DEVELOPMENT REVIEW BOARD

REGULAR MEETING MEMORANDUM

Item No. 4
Meeting Date: 7/16/2020
Topic: Updates to Material Board and Elevations
Request: Approve revised stipulations
From: Jeff Barnes, Senior Planner **JB**
Through: Brad Carr, AICP, LEED-AP, Development Review Board Coordinator **B**

Silver King Office & Car Storage 55-DR-2019

55-DR-2019
7/8/2020
A202
EXTERIOR ELEVATIONS
COLOR ALT

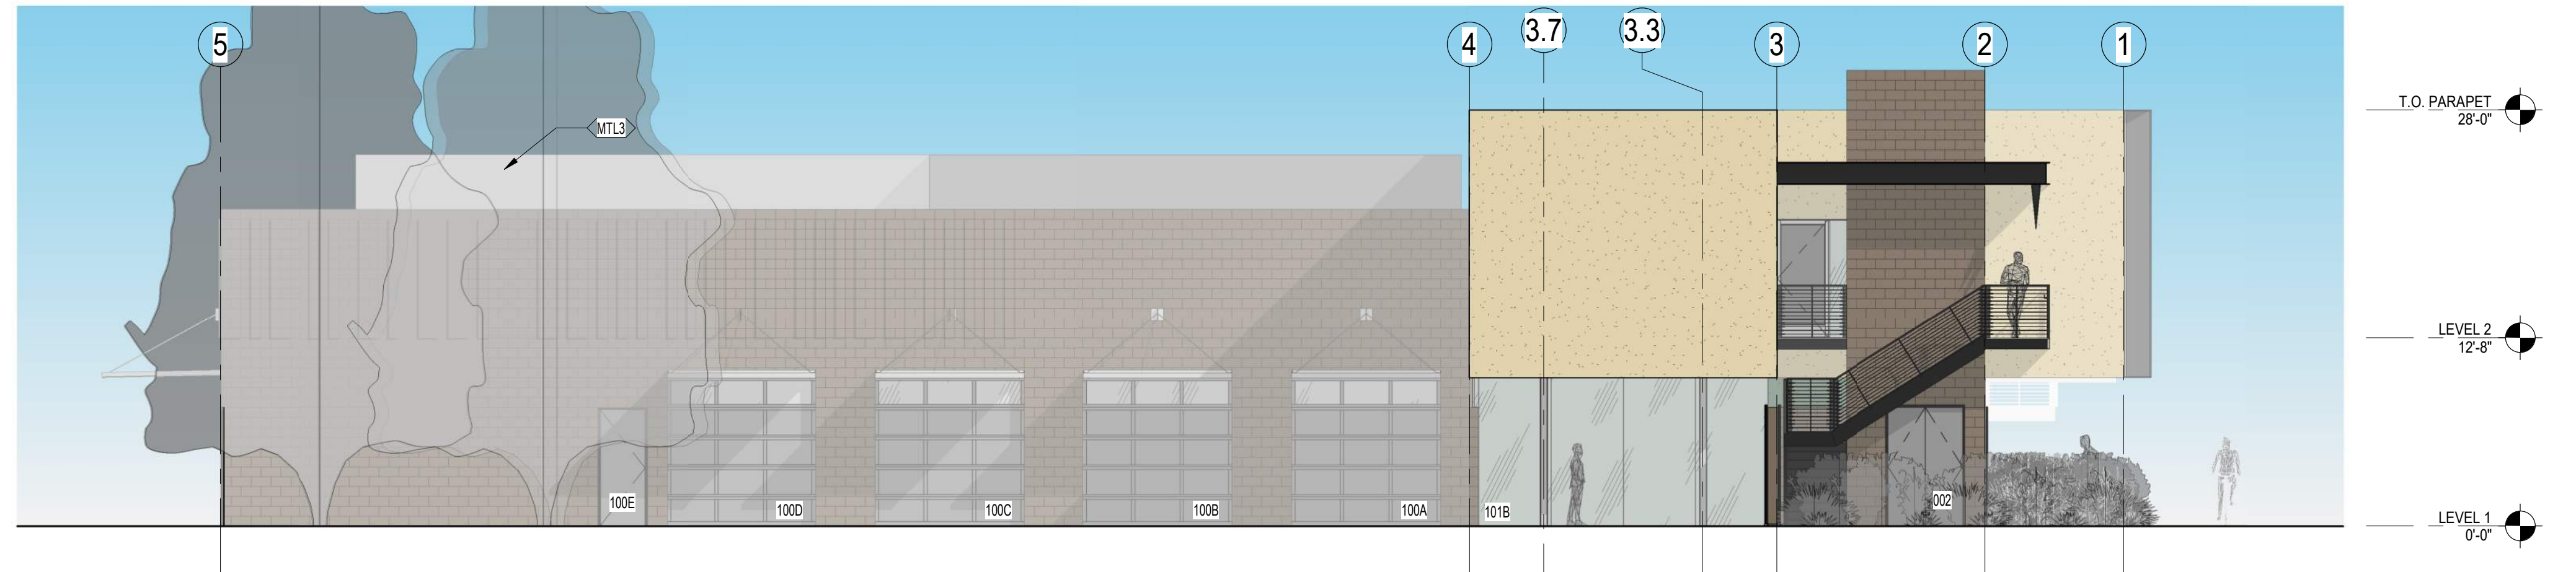
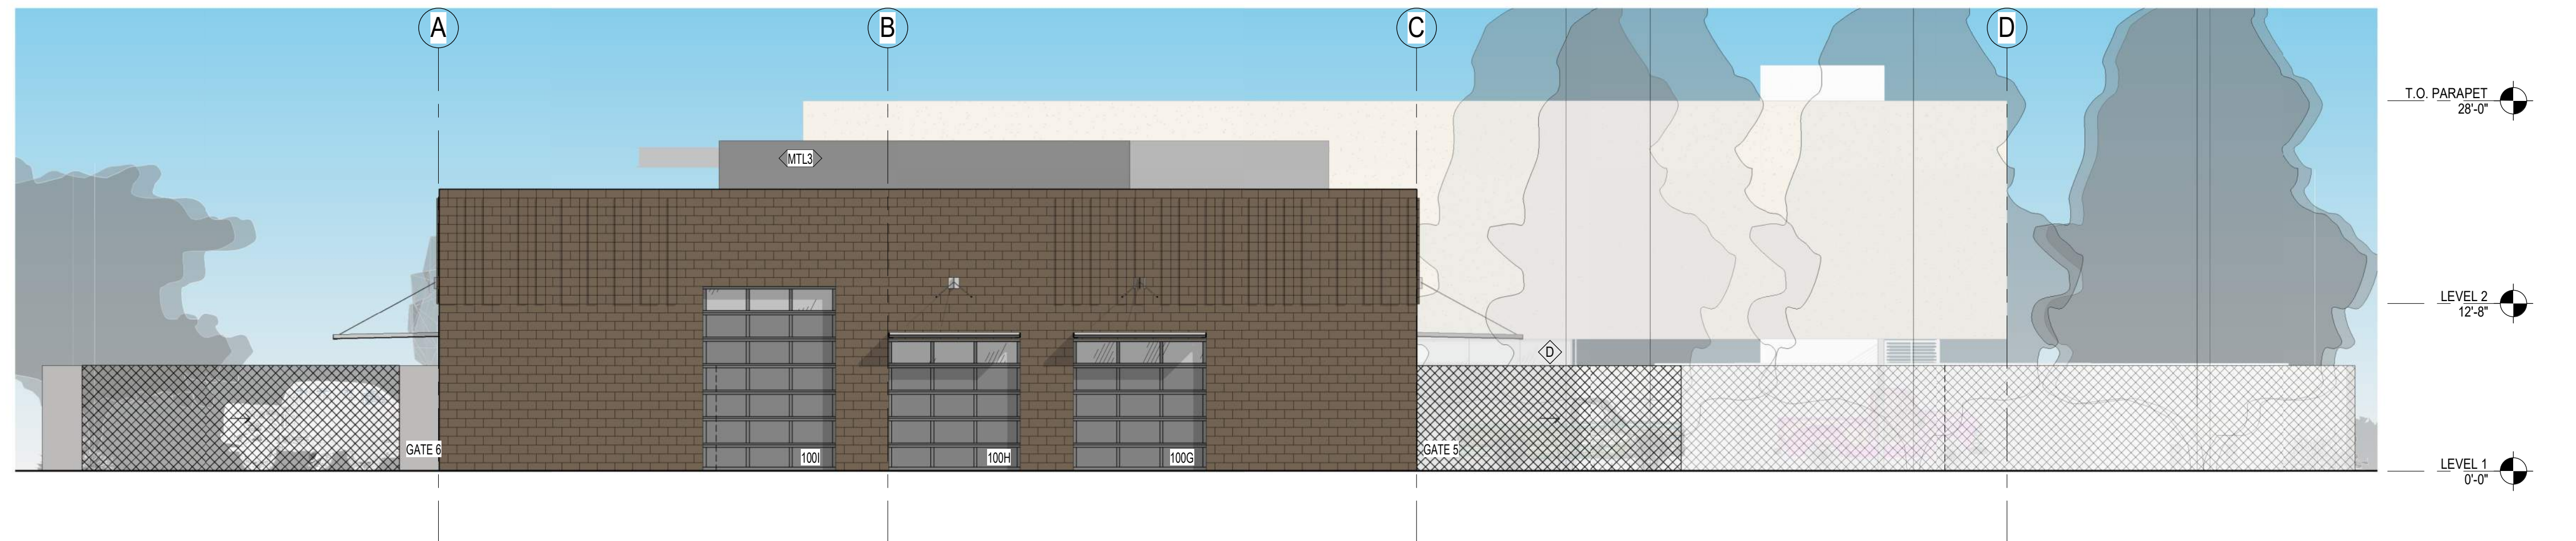
- ~~4. In accordance with the City of Scottsdale Commercial Design Guidelines, the color and material choices shall be revised to emphasize muted earth tones and address the Sonoran Desert environment. Including but not limited to the following:~~

- ~~a. A change in hue of the color palette from the currently proposed cool neutral tones to a selection of warm neutral tones.~~
 - ~~b. A reduction in the LRV of the currently proposed "Frostbite" (DE6274) [LRV 77] to a paint color with a maximum LRV of 70%.~~

- ~~c. A selection of block (or stone) that contains/conveys more earth tones than the "Standard Grey" CMU currently proposed.~~

Please consider in your action using the updated document date of 7/8/2020 for Stipulation #1 and striking the current language in Stipulation #4:

- a. Architectural elements, including dimensions, materials, form, color, and texture shall be constructed to be consistent with the building elevations submitted by Architekton, with a city staff date of ~~6/4/2020~~ **7/8/2020**.
